Windfarm committee report

The Highland Wind Farm – application under Section 36 of the Electricity Act 1989 for the construction and operation of a windfarm and energy storage facility within the Planning Authority of the Highlands Council, of 19 turbines, 14 turbines with a tip height of 200m and 5 turbines with a tip height of 230m. Anticipated generating capacity is 133 MW.

Consultation from: Scottish Government Energy Consents Unit

Reference: 2025/0080/PAC (ECU ref. ECU00005082)

Appendix I – Highland Wind Farm: Proposed windfarm ZTV

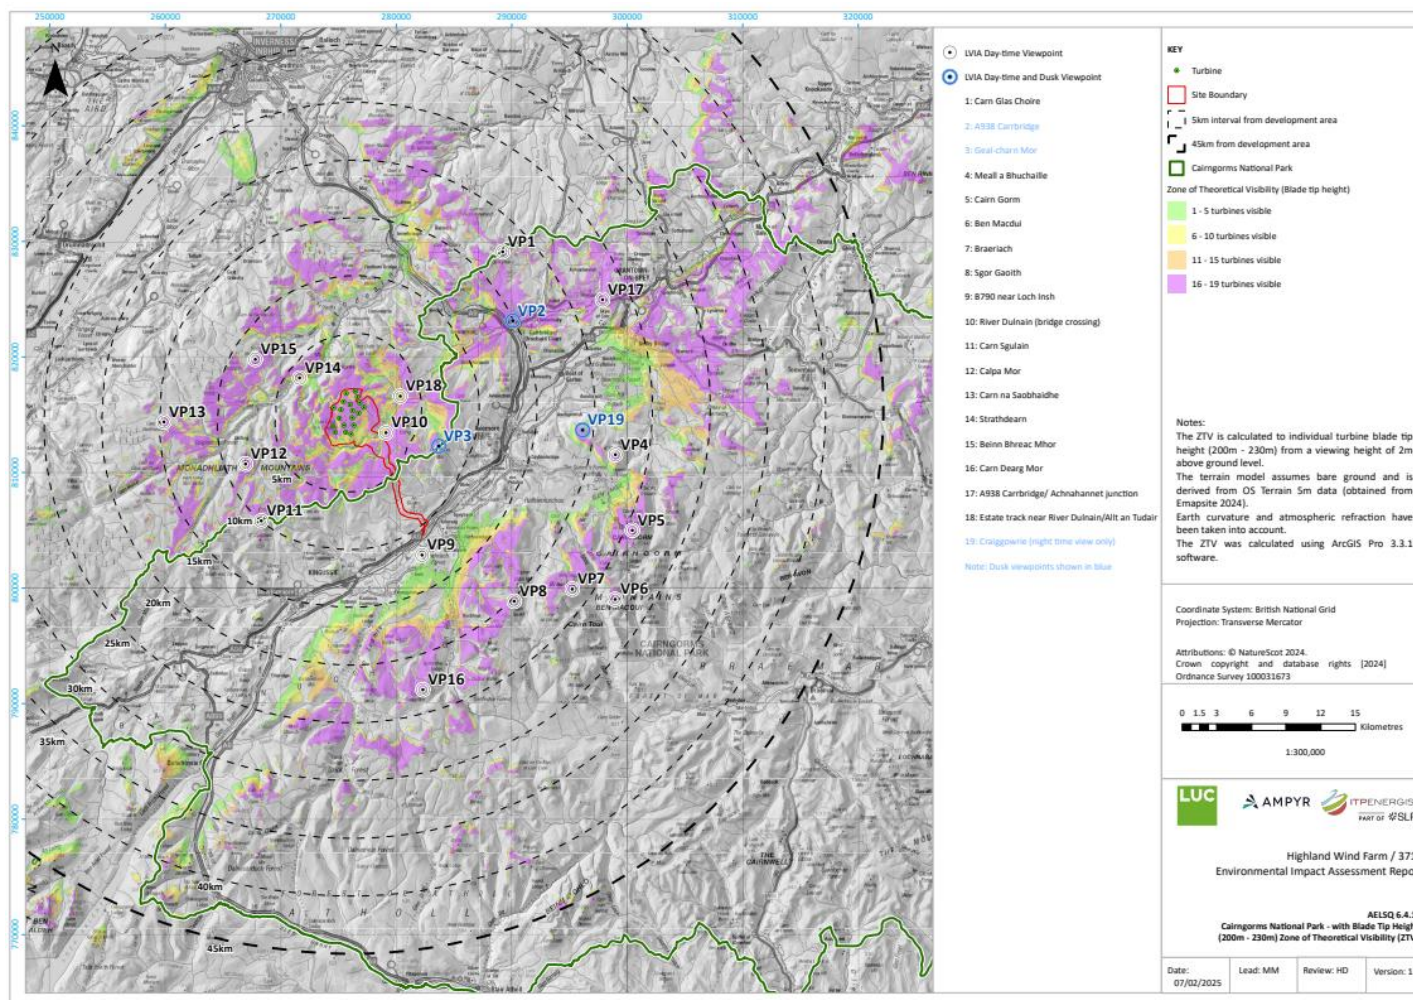
7. Theoretical visibility of the proposed windfarm from within the National Park is shown by the applicant's EIAR Figure 6.4.1 (**Appendix I**). When considering cumulative visual effects, the applicant's Figure 6.4.3 Cumulative – ZTV (**Appendix 2**) demonstrates the visibility of the proposed, consented and operational windfarms. The yellow and green areas show the increase in visibility of wind turbines with the introduction of the Highland Wind Farm.

8. Visualisations from 15 viewpoints were provided in the applicant's EIAR to demonstrate the predicted level of visibility that would be had from within / on the boundary of the National Park – refer to **Appendix 1** (Figure 6.4.1 Blade Tip ZTV with Viewpoints) for the locations:
